PLANNING & ZONING COMMISSION

Wednesday, December 9, 2015

1. SKETCH PLAN REVIEW

Applicant: Pulte Homes  
 Location: 8213 Steitz Road  
 Existing Zoning: Liberty Township, Farm Residential District (FR-1)  
 Proposed Zoning: City of Powell, PR, Planned Residential District  
 Request: To review a sketch plan for a proposed subdivision consisting of approximately 128 units on roughly 70 acres.

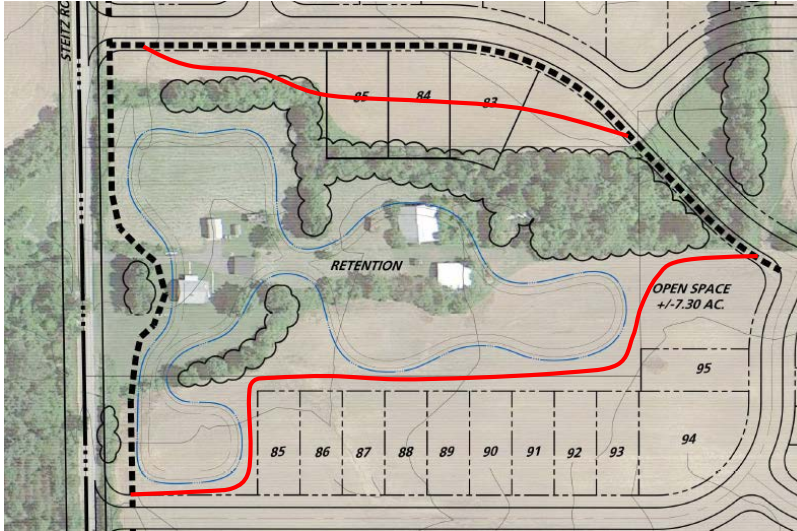
1. Remove lots 83, 84, and 85 from the northern main entrance road. This would increase the amount of open space and takes out lots that seem out of place. Furthermore, it would reduce the density of the project from 1.81 du/ac (dwelling units per acre) to 1.77 du/ac, which is more in line with the 1.7 du/ac maximum that staff feels is appropriate for this area of the city.

2. Have the multi-use paths go through the above open space area instead of at the edges. This would provide a loop trail that residents could use. Also, it improves safety, by taking the trail from the along the road to an interior space. Essentially, separating the pedestrian from the vehicle.

3. Consider connecting the two north east cul-de-sacs in order to create a loop street. This option has both positives and negatives that will need to be discussed at the next meeting. For instance, one positive is that by removing the dead-end streets, traffic flow is improved and reduces conflict points. This allows for better access for school buses, trash trucks, emergency vehicles, etc. A negative is more roadway and higher maintenance cost to the city, and less interconnectedness of open space. Staff defers to P&Z for direction.

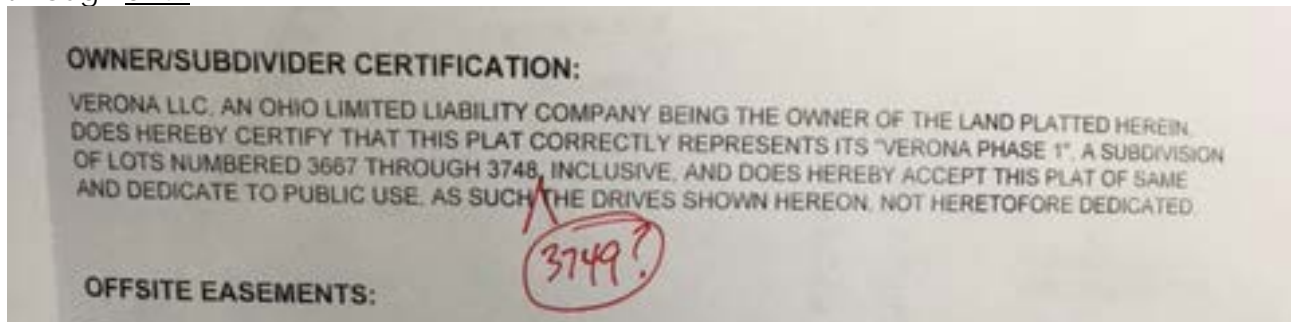
1. The fourth paragraph in the notes section on page 1 should actually read: First floor elevations shall not be altered without Powell building and Engineering department approval.
2. The notes section requires language for ownership and maintenance responsibility for open space lots 3696, 3697, 3748, and 3749.

3. Under the Owner/Subdivider Certification section, it should read: ...lots numbered 3667 through 3749...

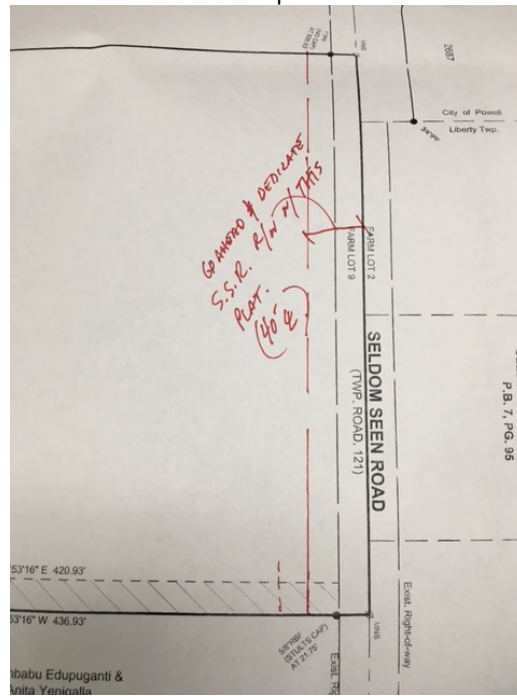
4. On sheet 4, the Seldom Seen Road right of way (ROW) should be dedicated with this plat. As a result, the applicant should draw onto the plat the 40 foot ROW.
